FILE NO. 260761

From the Planning Department (CPC), submitting Responses to Comments on the Draft Environmental Impact Report for the Pacific Gas and Electric (PG&E) Power Asset Acquisition Project. Copy: Each Supervisor. (2)

Date:	June 25, 2026
Case No.:	**2023-005370ENV**
Project Title:	**PG&E Power Asset Acquisition Project**
To:	Members of the Planning Commission and Interested Parties
From:	Lisa Gibson, Environmental Review Officer
Re:	Responses to Comments on the Draft Environmental Impact Report for the PG&E Power Asset Acquisition Project

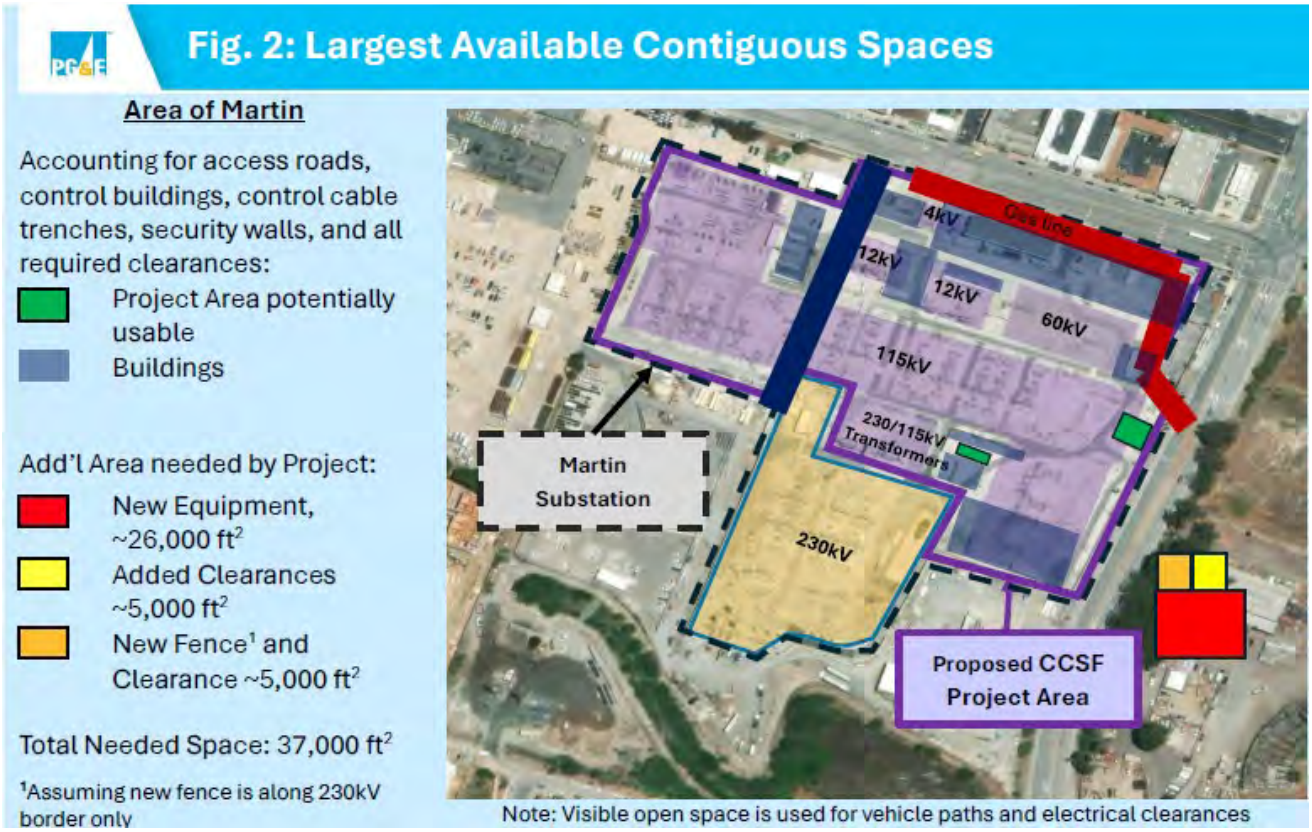
• **Challenges Associated with Project's Perimeter Wall, Access Road, and Electrical Clearances:** The Project requires an internal perimeter wall or walls to be installed around the portions of the Martin Substation site that would be separately owned and operated after CCSF's taking. It is unclear from the DEIR where such wall(s) would be needed/located, but it is obvious that one would be needed between the 230kV section to be retained by PG&E and the portions to the north taken by CCSF. There is not sufficient space for that required wall in light of clearances, access, and necessary new equipment.

Significant electrical clearances are required for such a wall or walls. The National Electric Safety Code (NESC) requires at least 15.5 feet between 230kV equipment and a perimeter wall, and at least 13 feet between 115kV equipment and a perimeter wall. (NESC Rule 234.) Installation of such wall(s) in accordance with the required clearances would place the wall(s) in or across existing access roads and/or in spaces where electrical equipment already exists or will be required. (See Figure above; see also Attachment A, pages 10–14.)

Figure 2. BART parking lot split between San Francisco and San Mateo Counties

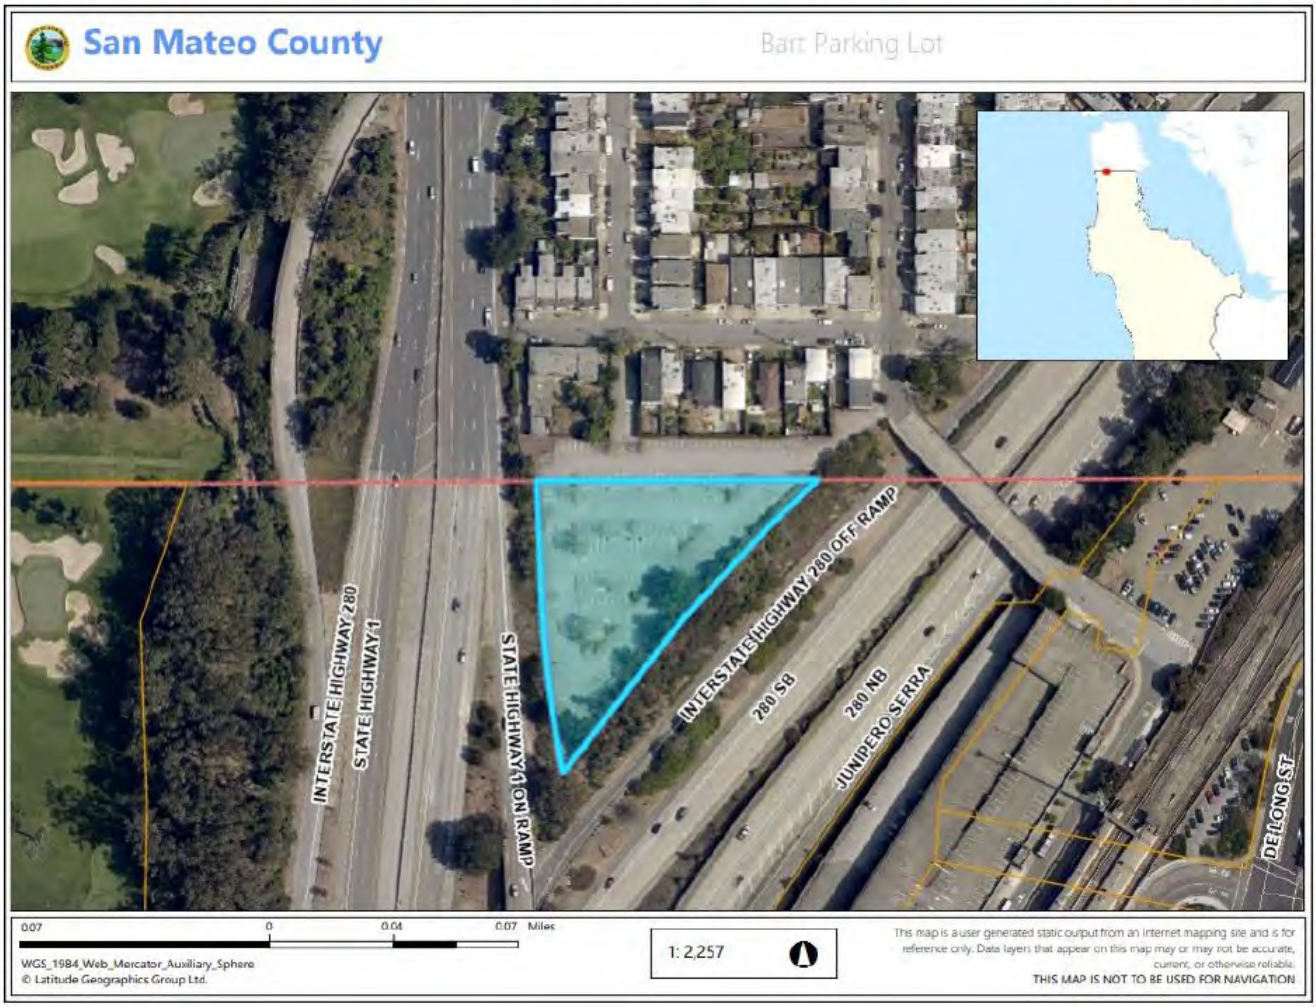
Another area that is not identified in the DEIR is the parking lot owned by the Bay Area Rapid Transit (BART) in the City of Daly City (APN 002-221-010). As shown in Figure 2 below, the northern segment of the parking lot is in San Francisco County and southern part is in San Mateo County. San Mateo LAFCo recommends the addition of clarifying language and exhibits in the Final EIR regarding electrical service to these areas and all areas within the Project area that are located in San Mateo County.

In further response to Comments A-LAFCO.1 and A-LAFCO.2, as stated in the Draft EIR (p. 2-2), the project does not propose to extend SFPUC electric service to customers outside of San Francisco. Figure 2-1 is intended to provide a general overview of the project area and is not required under CEQA to show parcel-level delineation or identify specific service providers for individual parcels. For parcels split by the San Francisco-San Mateo County boundary, the Draft EIR evaluates potential impacts at a program level. The types of separation activities and the geographic areas where work would occur are identified in the Draft EIR, and the foreseeable impacts of these activities are estimated. As discussed in Response PD-2, this level of detail is sufficient for CEQA impact analysis.

Necessary equipment required physical spacing exceeding existing 35-foot space

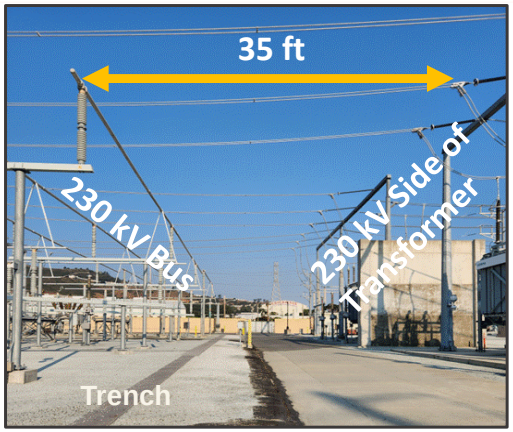
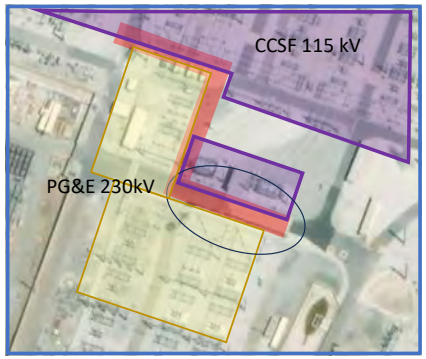
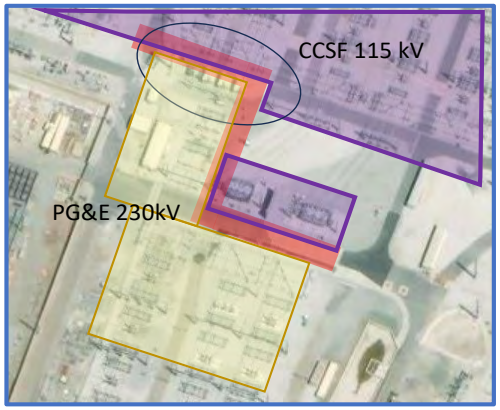
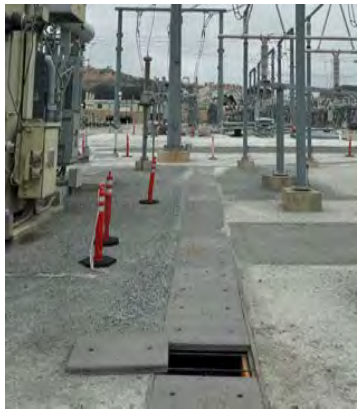
- PG&E must retain access road
- Install two new 230kV breakers and disconnect switches
- New metering/control building(s)
- New perimeter security wall

Total distance required: at least 80 ft ---- Total space available: 35 feet
